Ref: **R/190/13**

Re: Land to the rear of 20 & 22 Broadmark Lane, Rustington.

We OBJECT to the proposed application for a large detached dwelling at the above site.

DRAWING TITLE
SITE LOCATION AND LAYOUT PLANS

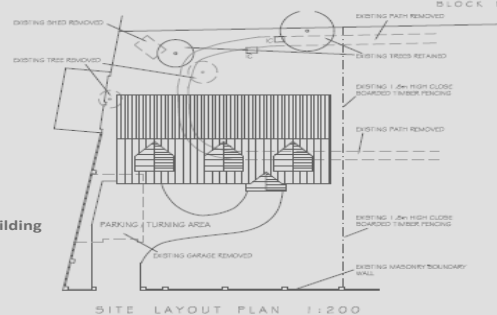
- 2) The 2010 proposal was sited between the rear of 22 Broadmark Lane, some 13 metres from its rear wall, and 4 Broadmark Way, some 7.5 metres from its flank wall. The house now proposed is 9.5 metres from the rear wall of 20 Broadmark Lane, and 4 metres away from the flank of 4 Broadmark Way. This is 27% closer to Broadmark Lane, and 46% closer to 4 Broadmark Way.

- 3) The 2010 proposal reduced the garden size of 22 Broadmark Lane by approximately 170 sq. metres, making both its overall plot size and that of the proposed dwelling uncharacteristically small. The house now proposed reduces the garden size of both 20 and 22 Broadmark Lane by approximately 400 sq. metres making both existing plot sizes uncharacteristically small.

(2) 13 metres from west wall of 22 Broadmark Lane to east wall of new proposal.

(3) 170 sq metres
